Amendments to the Albany Development Code (ADC)

Draft code amendments are written as follows: additions **bold red underlined** and deletions in ~~strike-out~~. Sections not amended are omitted unless needed for context. Omitted sections are indicated by asterisks: ***

ARTICLE 8 DESIGN STANDARDS

FIGURE 8.140-1. Determining whether a proposal is “infill development” (example)

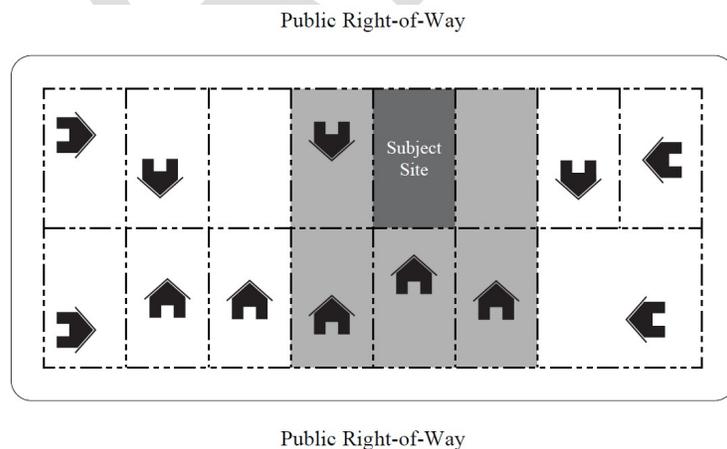
Subsection (2) clarifies how to perform the calculation to determine whether a proposed development qualifies as “infill” (greater than 75% of abutting parcels have comparable dwellings). The outcome of the calculation will be consistent with the existing Code, but the process is clearer. The graphic in Figure 8.140-1 provides an example of how the calculation is performed.

(2) Determining whether a proposal is “infill development.” To determine whether the proposed development on the subject site is infill development (see example in Figure 8.140-1):

FIGURE 8.140-2. Infill development setbacks – Identifying comparable dwellings (example)

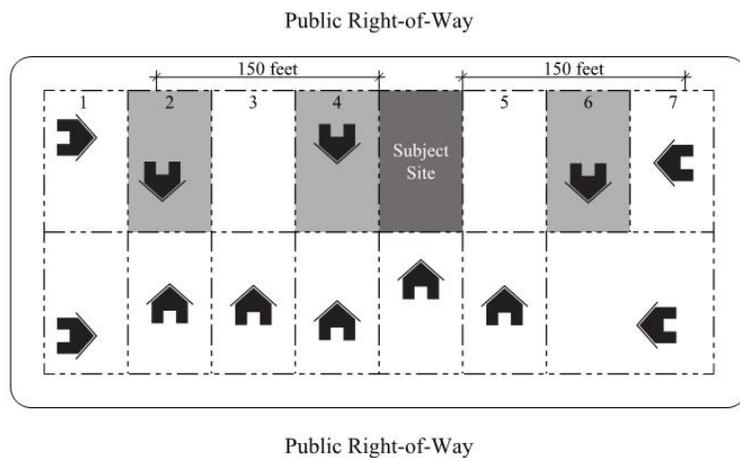
In addition, setback standards are formatted in a table to make them easier to read, and Figures 8.140-2 and 8.140-3 are added to illustrate how to identify comparable dwellings for the analysis and how to apply the setback standards.

(4) Minimum and Maximum Front Setbacks. The minimum and maximum front setbacks of an infill development are based on an evaluation of comparable dwellings that meet the following criteria (see example Figure 8.140-2):

FIGURE 8.140-3. Infill development setbacks –Applying the setback standards (example)

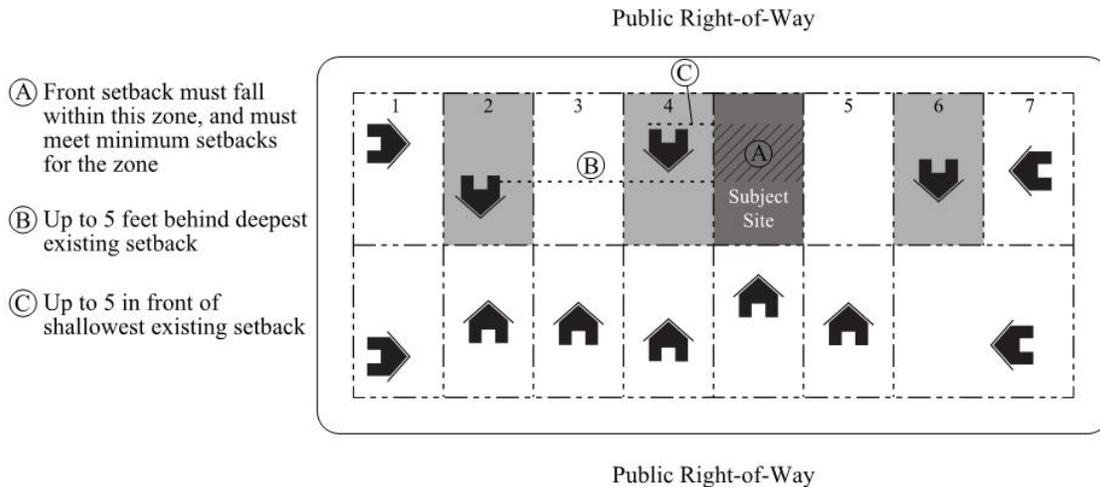
- (a) Infill development is subject to the minimum and maximum setback standards in Table 8.140-1 (see example in Figure 8.140-3). Notwithstanding the foregoing, no development shall be located such that it violates minimum setback standards for the zoning district.**

FIGURE 8.140-4. Infill Development garage / carport requirements – Identifying comparable lots (example)

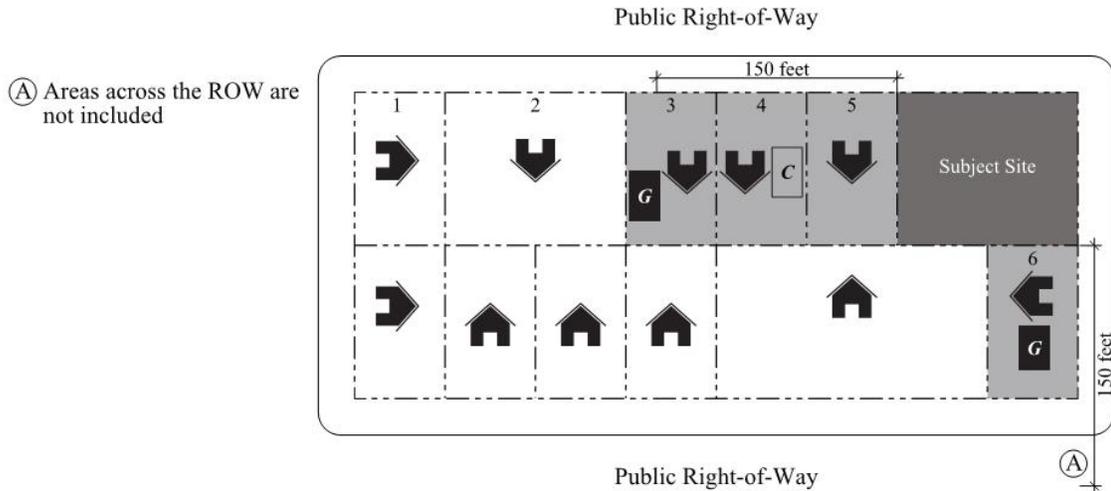
Also consistent with the setbacks section, standards in this section are formatted in a table to make them easier to read, and Figures 8.140-4 and 8.140-5 are added to illustrate how to identify comparable dwellings for the analysis and how to apply the garage/carport standards.

(5) Required Garage or Carport. Infill development may be required to have a garage or carport based on an evaluation of comparable dwellings that meet the following criteria (see example in Figure 8.140-4):

FIGURE 8.140-5. Infill Development – Applying the garage / carport requirements (example)

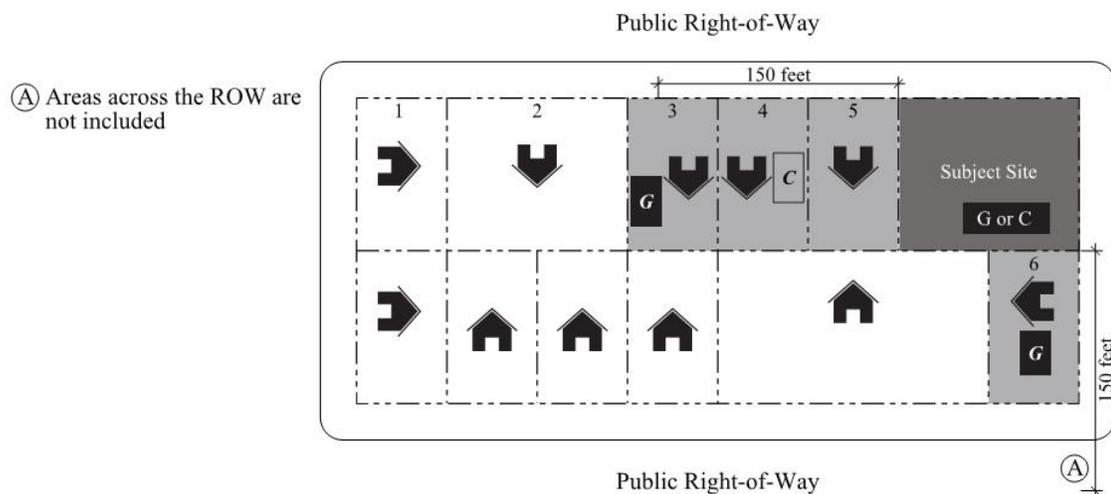
(a) A proposed infill development requires a garage or carport as specified in Table 8.140-2 (see example in Figure 8.140-5)

FIGURE 8-4. Existing House Heights: For this example, the maximum height is two stories.

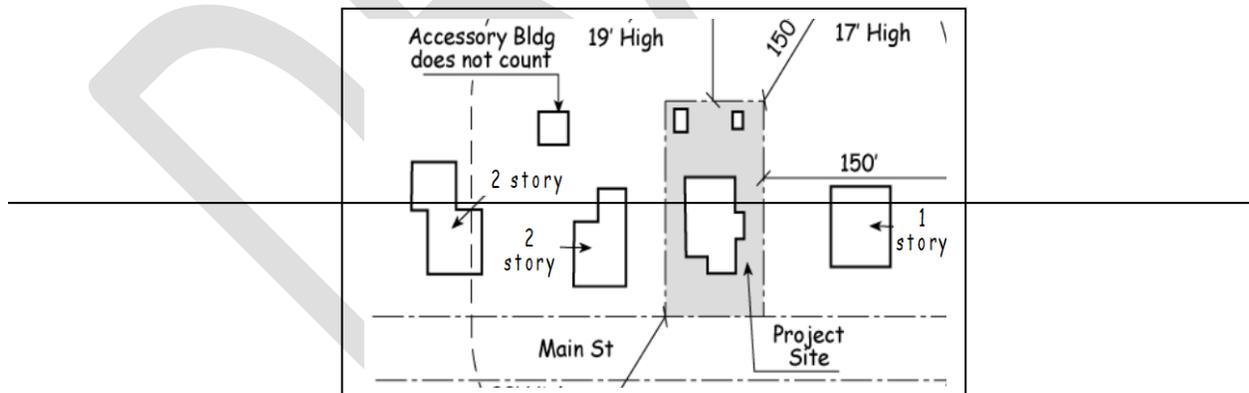
- (c) ~~Building Height. A home shall be no more than one story higher than the lowest home when compared with homes on either side of the subject property. See Figure 8-4.~~

(6) Maximum Building Height. The maximum building height of an infill development is based on an evaluation of comparable dwellings on comparable lots that meet the following criteria:

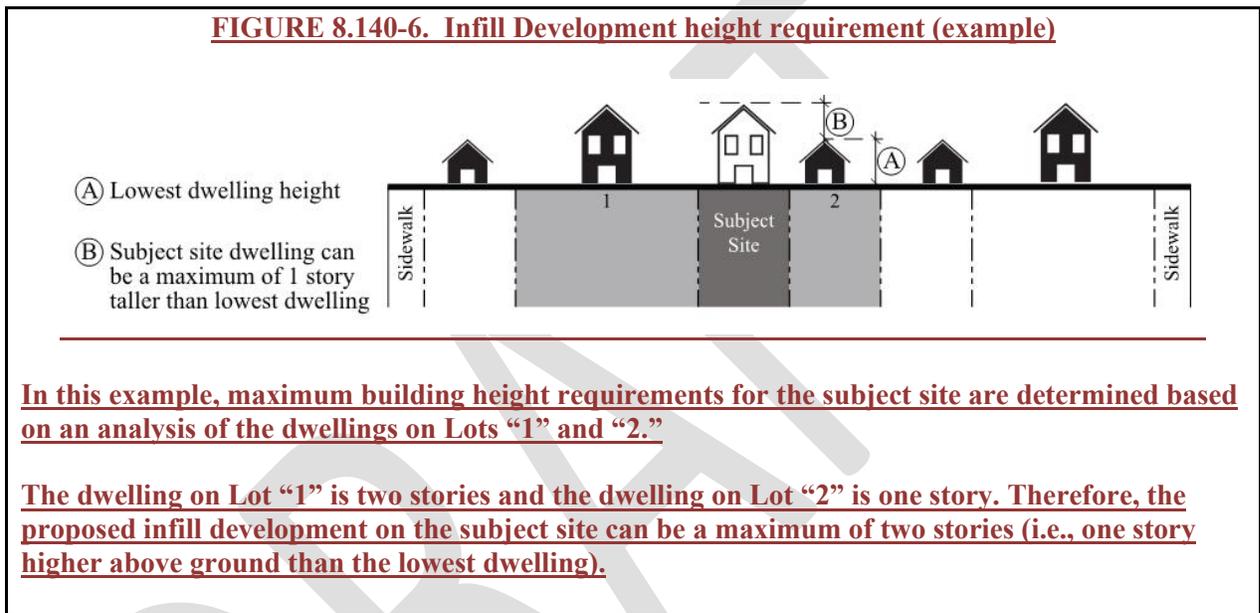
Also consistent with the setbacks and garage/carport sections, Figure 8.140-6 is added to illustrate how to identify comparable dwellings for the analysis and how to apply the building height standards.

If only one comparable dwelling meets the above criteria, the subject site is exempt from the infill height standards in this subsection (see example in Figure 8.140-6).

FIGURE 8-7 8.255-1. Regulated façades for Façade Design, Articulation and Window Standards. [Ord. 5894, 10/14/17]

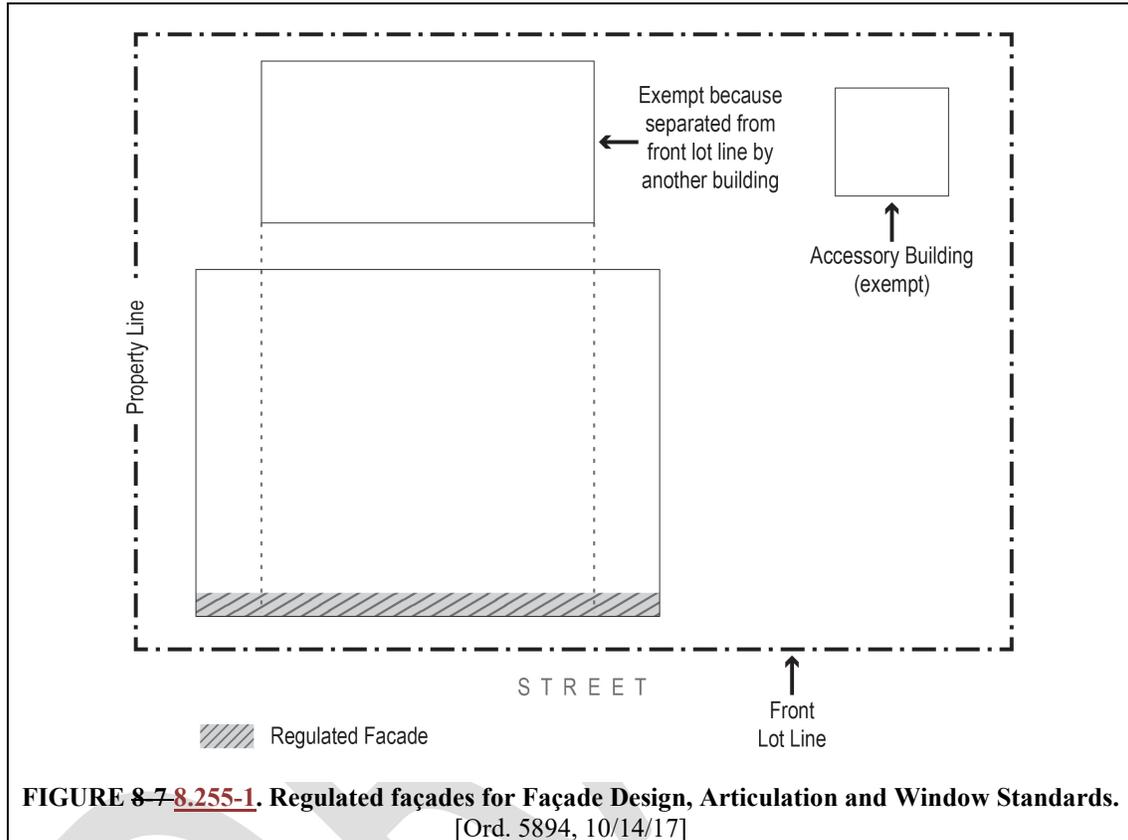
of a building that is separated from the front lot line by another building, based on a line perpendicular to the front lot line (see Figure 8.255-1-7). [Ord. 5894, 10/14/17]

FIGURE 8.345-1-7. Regulated façades for Façade Design, Articulation and Window Standards.
[Ord. 5894; 10/14/17]

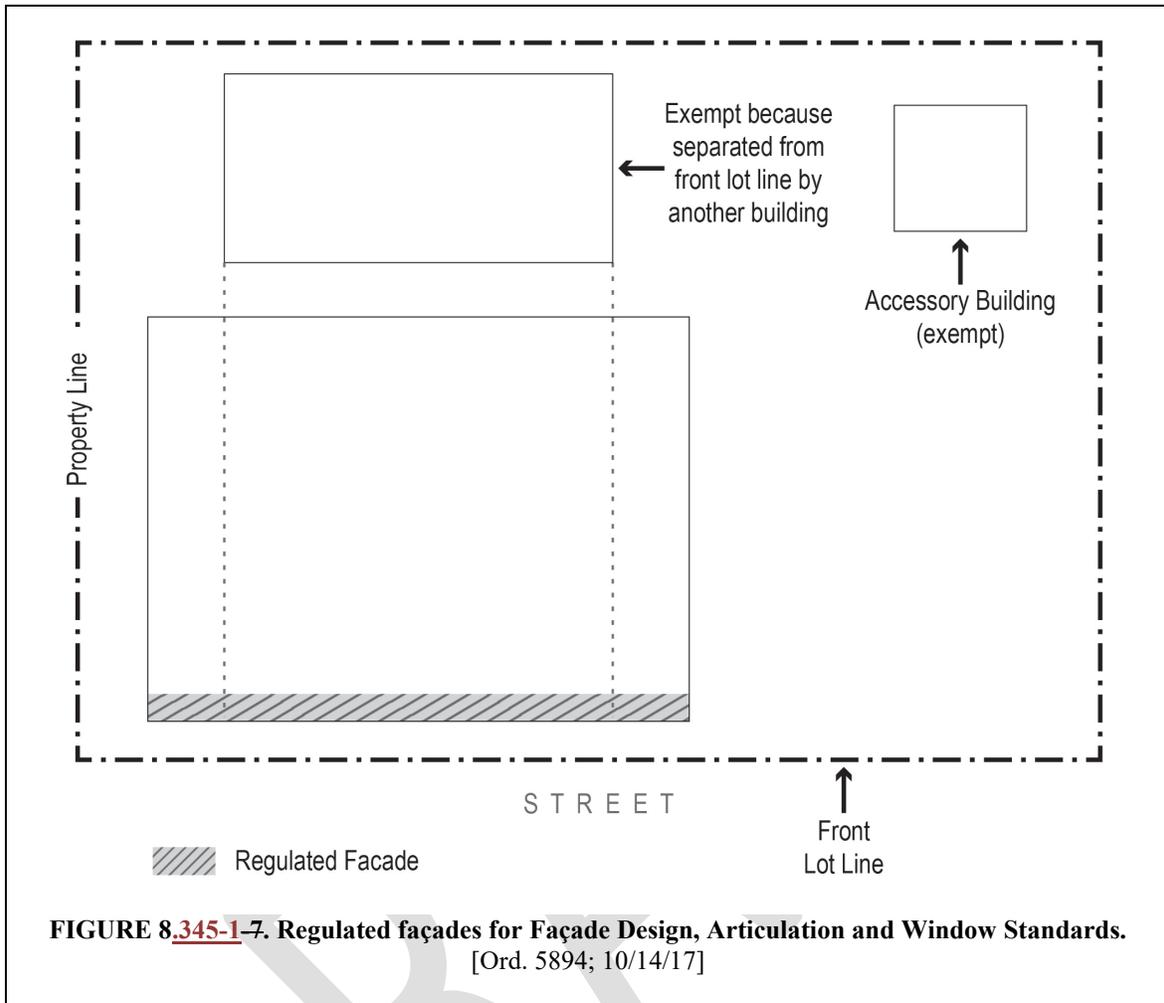
- (a) Where there is more than one building on the site, these standards do not apply to any portion of a building that is separated from the front lot line by another building, based on a line perpendicular to the front lot line (see Figure 8.345-1-7). [Ord. 5894; 10/14/17]
